1 **DRAFT SAFETY EVALUATION BY THE OFFICE OF NUCLEAR REACTOR REGULATION**
2 **TOPICAL REPORT 3002010613, “BENCHMARKS FOR QUALIFYING FUEL REACTIVITY**
3 **DEPLETION UNCERTAINTY—REVISION 1” AND TOPICAL REPORT 3002010614,**
4 **“UTILIZATION OF THE EPRI DEPLETION BENCHMARKS FOR BURNUP CREDIT**
5 **VALIDATION—REVISION 1”**
6 **PROJECT NO. 689/DOCKET NO. 99902028**

Figure 1. Results of the Linear Model Fitting.

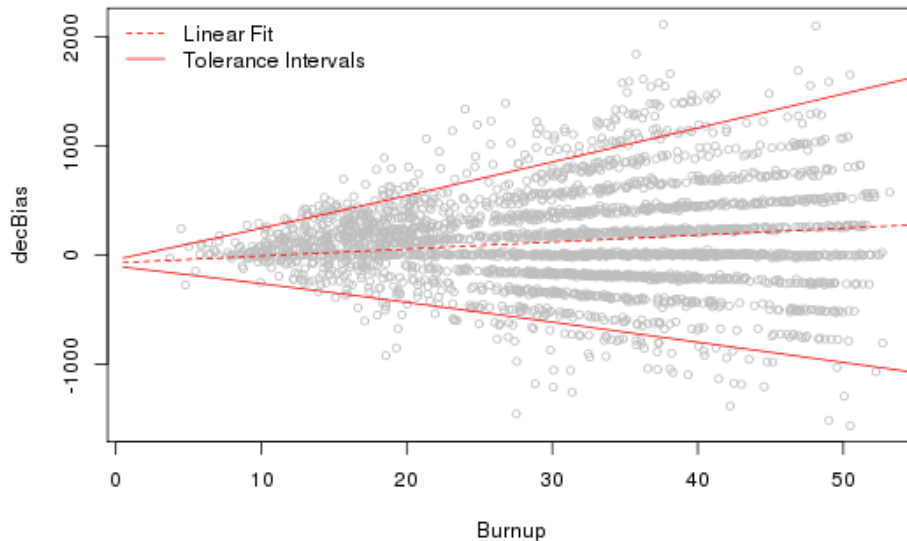
15 The results of the analysis assuming a linear function for the average decrement bias as a
16 function of burnup are shown in Figure 1. The correlated heteroskedastic error structure within
17 each sub-batch was assumed to be an AR(1) (with scaling parameter of 0.83 and a single
18 stationary variance for all sub-batches) multiplied by the burnups.

Figure 2. Results of the Quadratic Model Fitting.

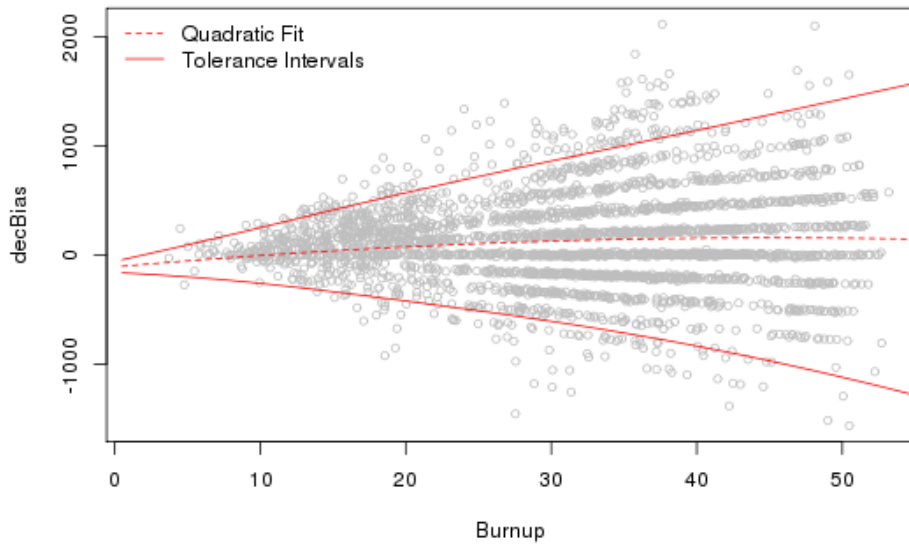
7 The results of the analysis assuming a quadratic function for the average decrement bias as a
8 function of burnup are shown in Figure 2. The estimate of the stationary standard deviation was
9 14.14. So the estimate of the standard deviation of the decrement biases for a burnup of x is
10 $14.14x$. The one-sided upper 95/95 tolerance interval fails to include 146 of the 2856 data
11 points (5.112 percent). The one-sided lower 95/95 tolerance interval fails to include 85 of the
12 2856 data points (2.976 percent). The estimate of the quadratic term is not very statistically
13 significant (the t -value is only -1.66), so the linear model analysis is preferred.

Figure 3. Plot of the Decrement Bias divided by Burnup.

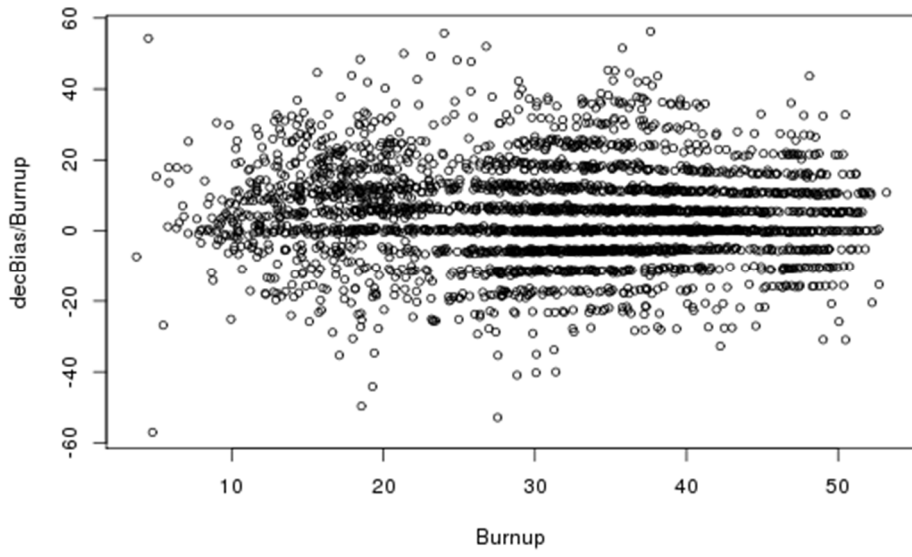
16 Figure 3 supports the assumed heteroskedastic error structure because dividing the decrement
17 biases by the burnups produces a substantially more homoscedastic looking data plot. Some
18 obvious structure in the data is not accounted for in the modeling. The lines of data are not
19 explained by the sub-batching of the data. This type of structure is likely caused by the use of
20 discrete burnup multipliers in the error deduction algorithm described in Section 6.4, "Iteration
21 Implementation," of the EPRI benchmark report.
